Re: Florida Power & Light Company
Proposed Turkey Point Units 6 and 7
Docket Nos. 52-040 and 52-041
Response to NRC Request for Additional Information Letter No. 037
(eRAI 5896) SRP Section - 02.05.02 Vibratory Ground Motion

FPL Response to NRC RAI No. 02.05.02-2 (eRAI 5896)

NRC RAI Number: 02.05.02-2 (eRAI 5896)

Re: Florida Power & Light Company
Proposed Turkey Point Units 6 and 7
Docket Nos. 52-040 and 52-041
Response and Response Schedule to NRC Request for Additional Information
Letter No. 037 (eRAI 5896) SRP Section - 02.05.02 Vibratory Ground Motion

Figure 12a. Caribbean 2.5Hz weighted mean attenuation curve for a magnitude 6 earthquake.

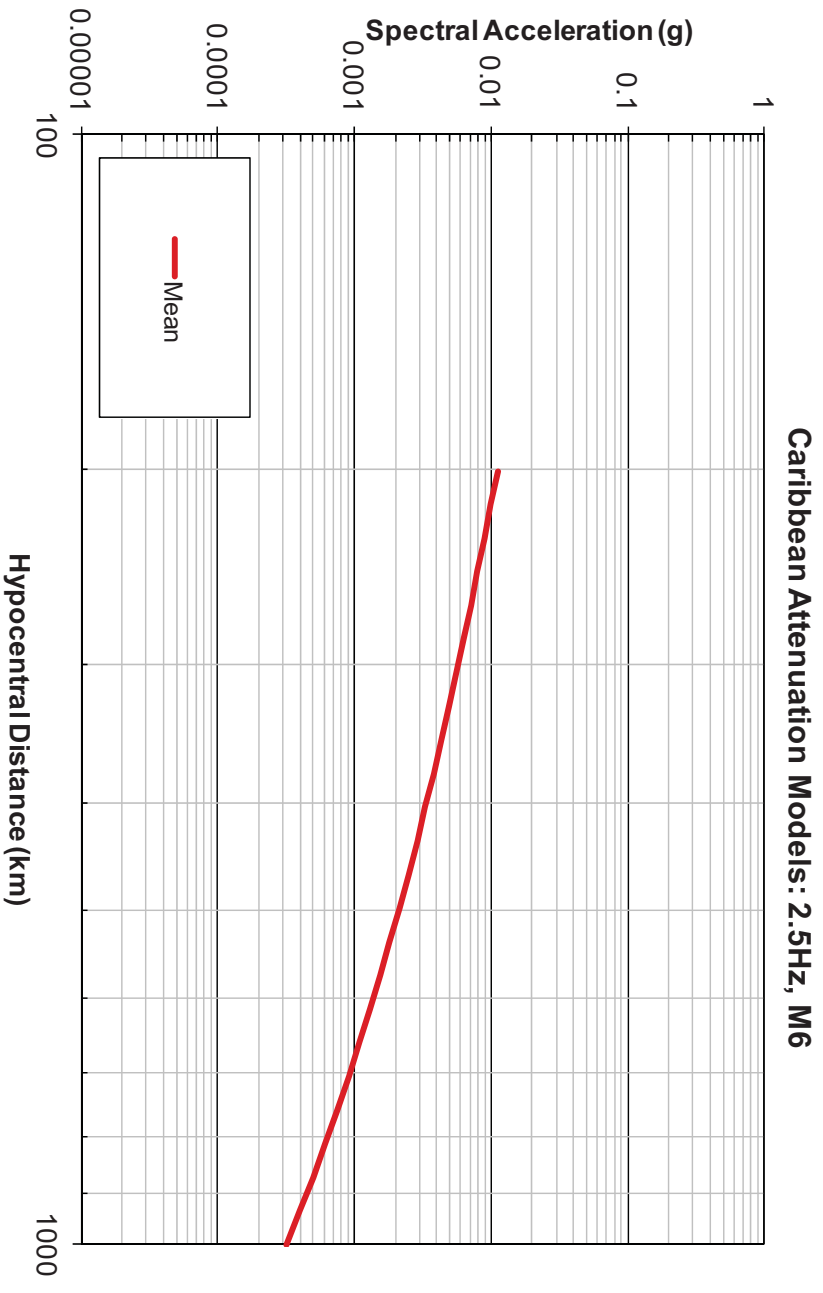
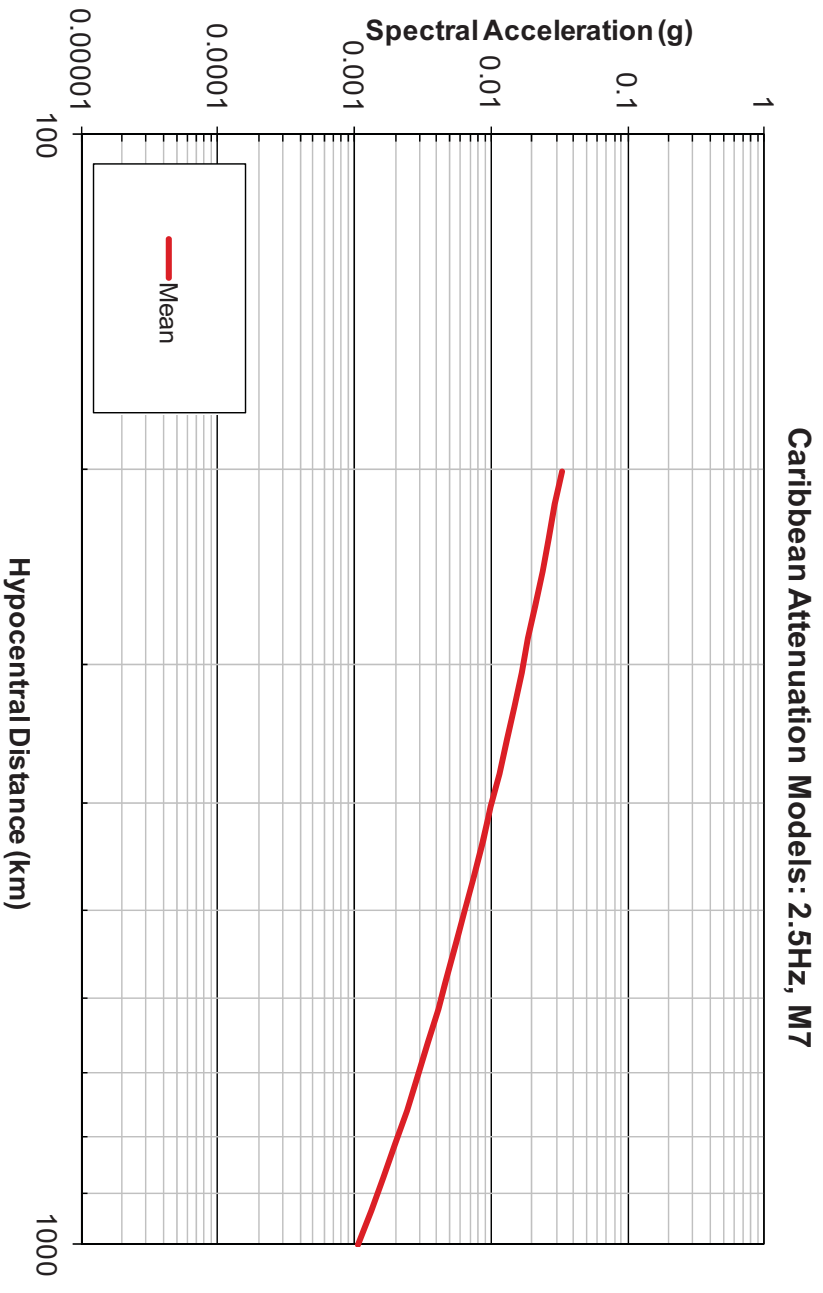
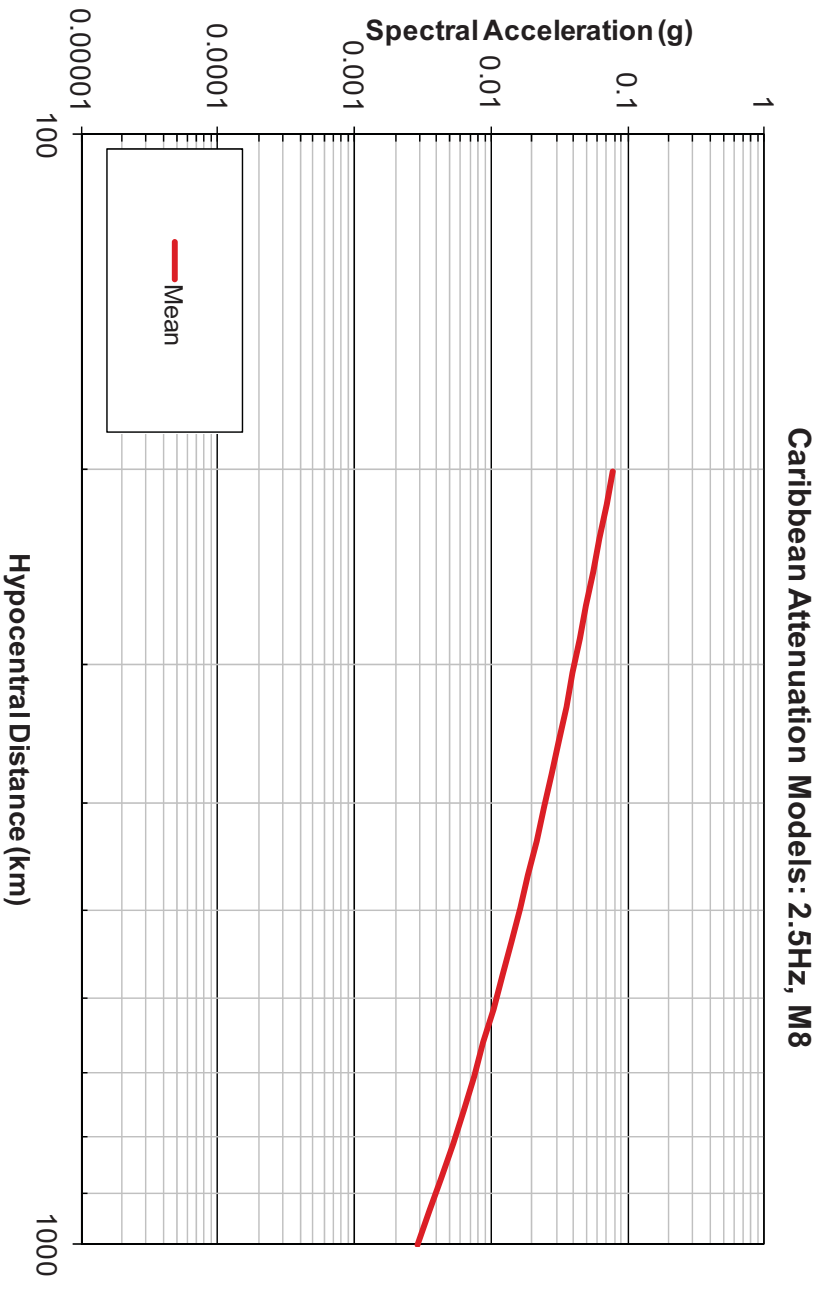
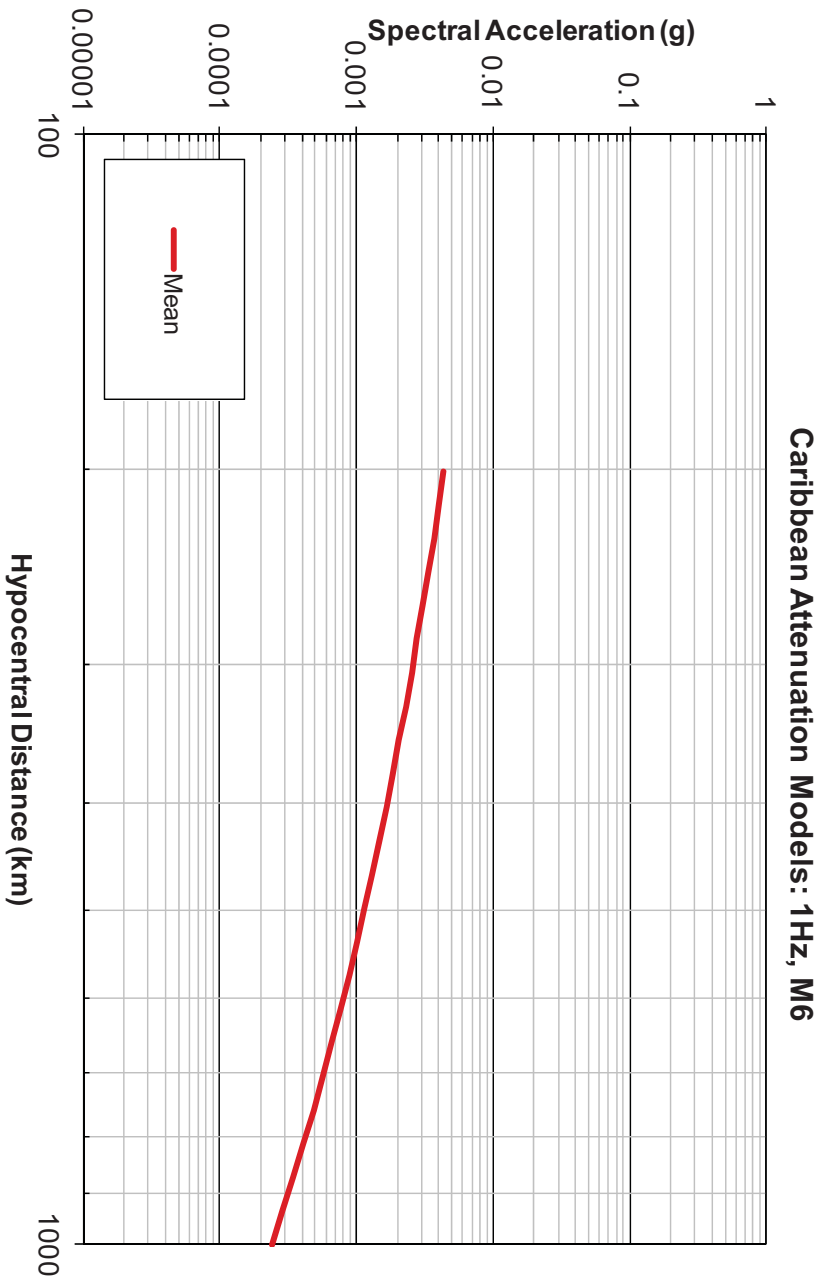
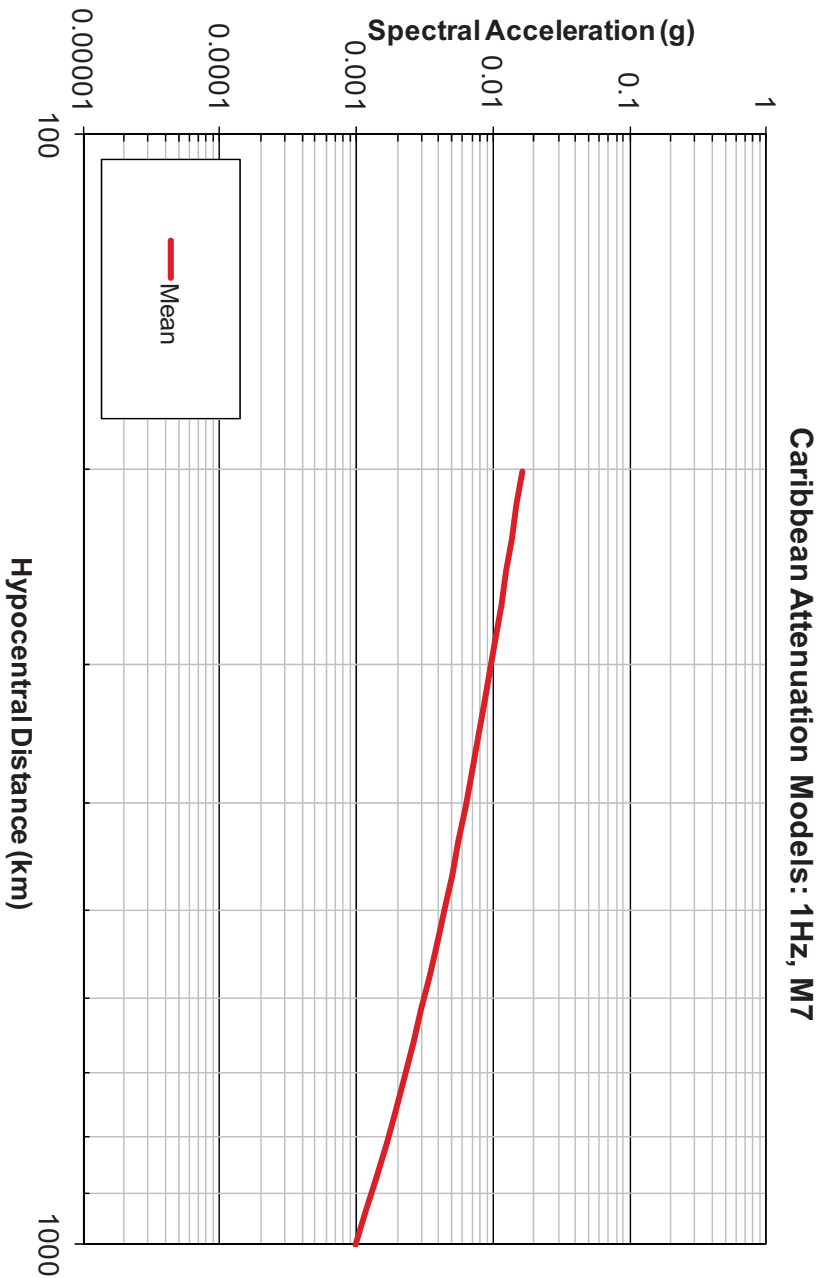
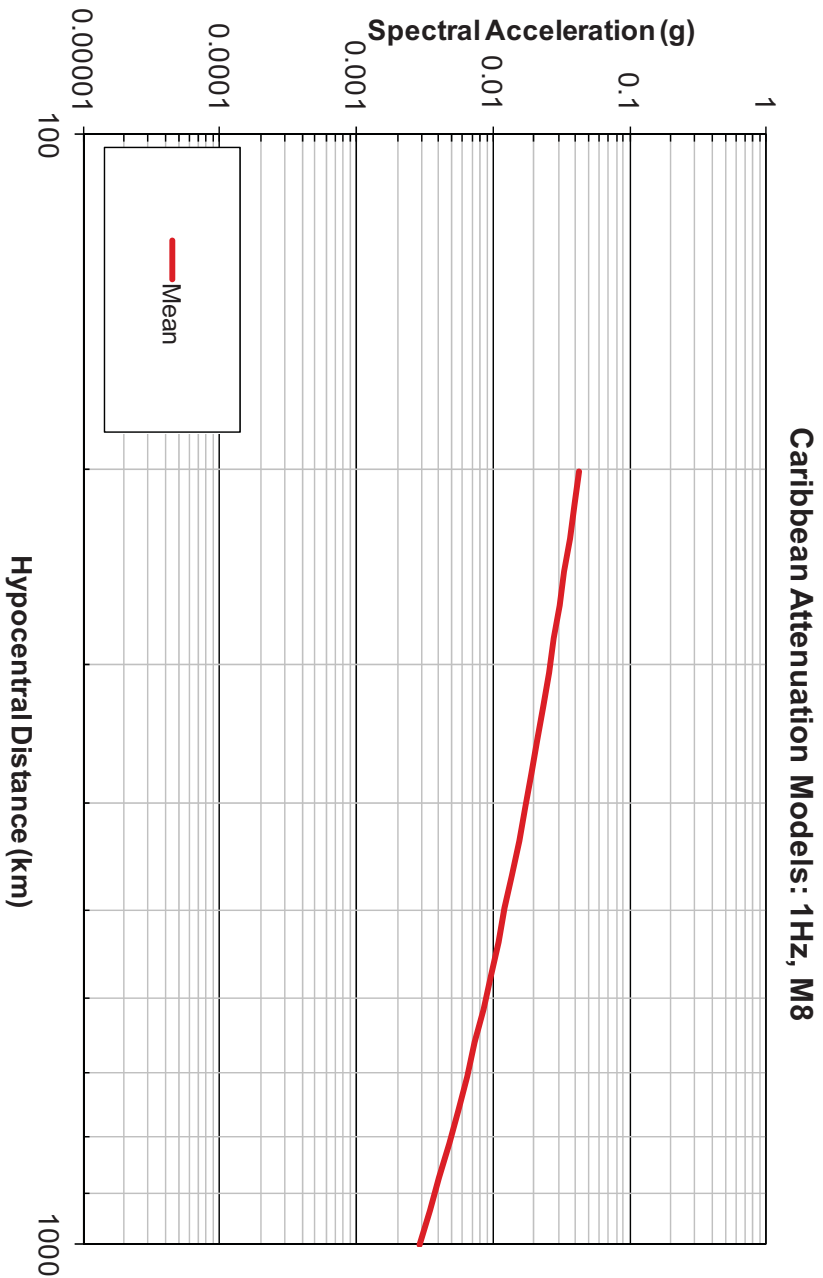
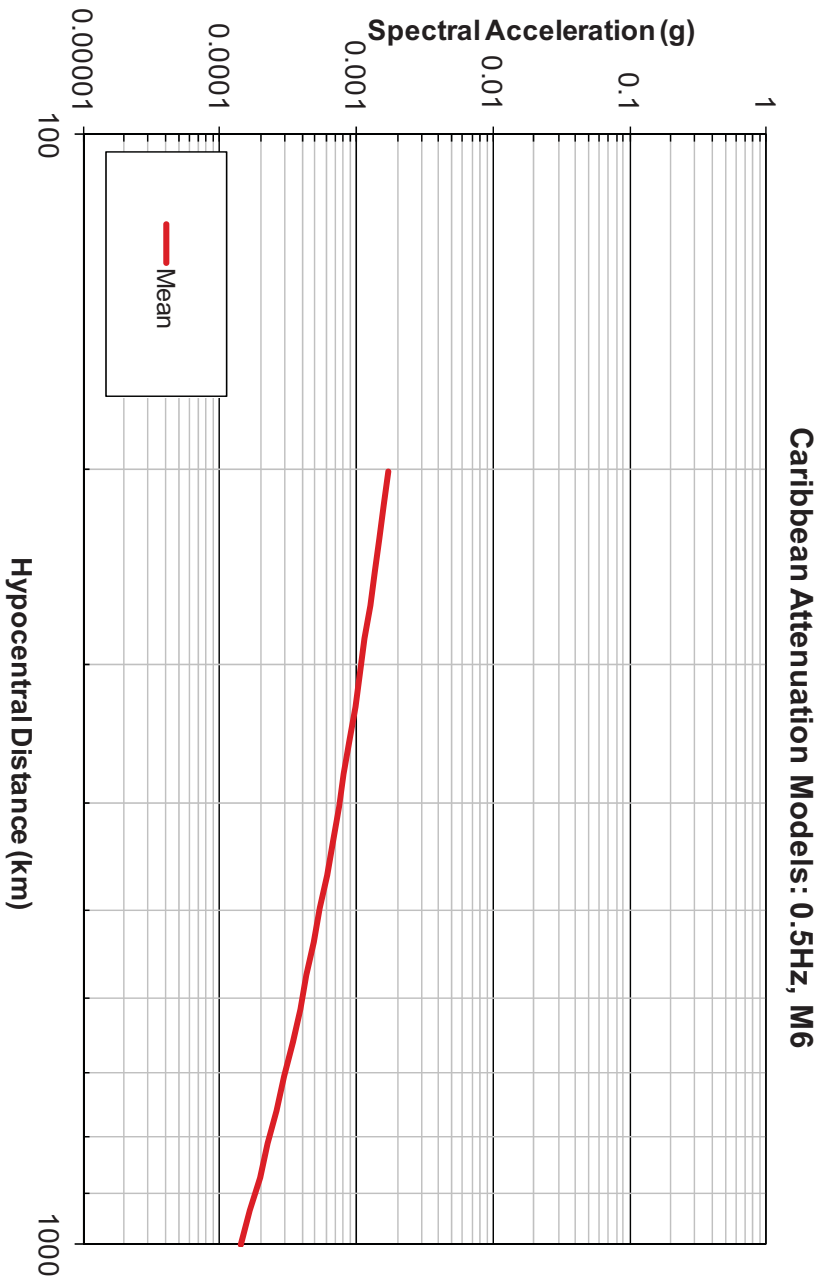
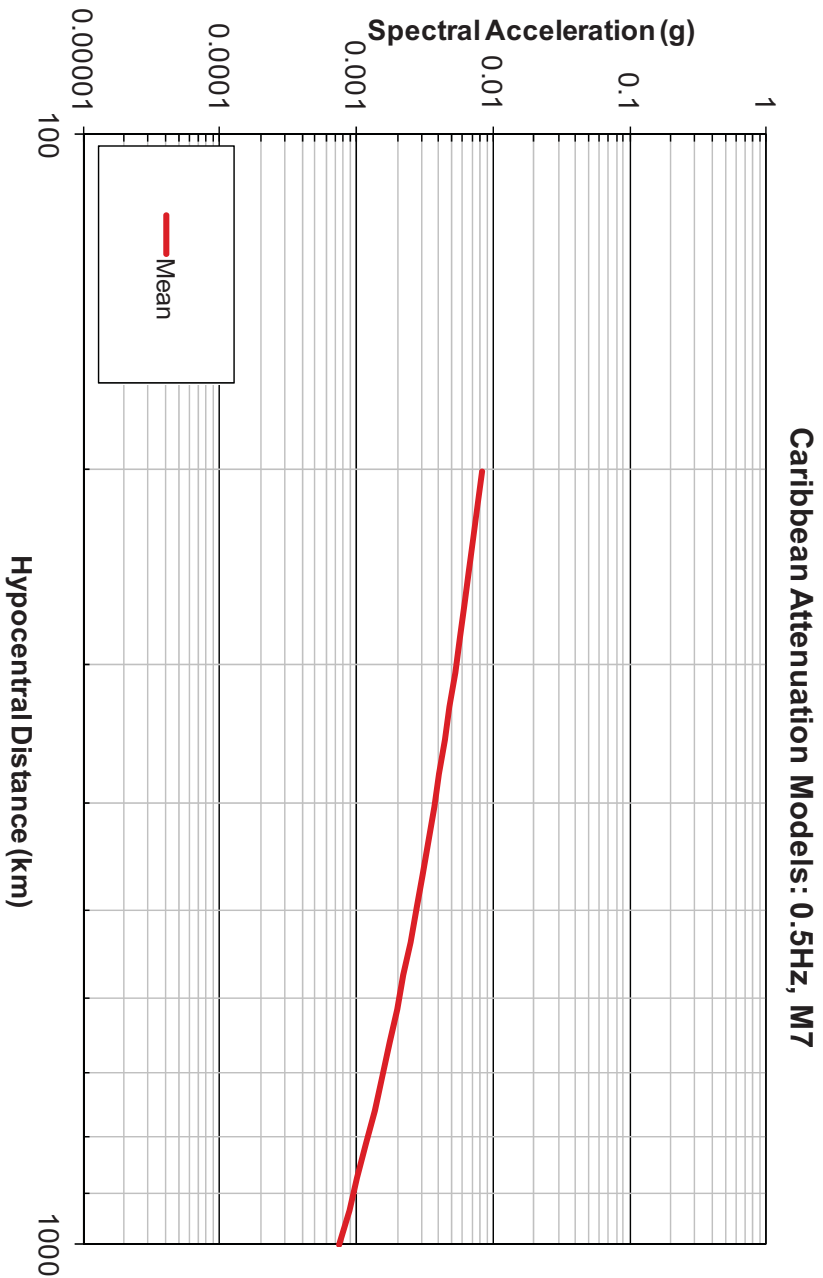
- d. In order for the staff to be able to compare the new Caribbean GMPEs with the 2004/2006 EPRI mid-continent GMPEs, please provide plots showing both ground motion models for earthquake magnitudes of 6.0, 7.0, and 8.0 in the distance range of 200 km to 1000 km at all seven frequencies defined in the EPRI 2004 and 2006 GMPEs.

Ground motion attenuation curve plots are provided for the EPRI (FSAR References 242 and 203) and Caribbean ground motion prediction equations (GMPEs). Note that EPRI (FSAR Reference 203) is only a recommendation for the associated aleatory uncertainty and therefore does not impact the comparison plots of the weighted mean ground motion

attenuation curve. The plotted mean attenuation curve is the weighted mean of the individual median attenuation curves as defined in EPRI (FSAR Reference 242). These attenuation plots are provided for three specific moment magnitude (M_w) values: 6, 7, and 8 for distances between 200 km and 1,000 km. Note that the EPRI (FSAR Reference 242) ground motion attenuation model is defined as a function of epicentral distance, whereas the Caribbean ground motion attenuation model is defined as a function of hypocentral distance. However, because the closest distance is 200 km, the difference between the epicentral and hypocentral distances would be less than 1% for a typical crustal depth of 10 km and even smaller for larger distances out to 1,000 km.

The weighted mean ground motion attenuation curves for the EPRI (FSAR Reference 242) model are given in Figures 1 through 7 for the three magnitudes and seven spectral frequencies requested in the RAI. The weighted mean Caribbean ground motion attenuation curve plots for the same suite of magnitudes, distances, and spectral frequencies are shown in Figures 8 through 14.
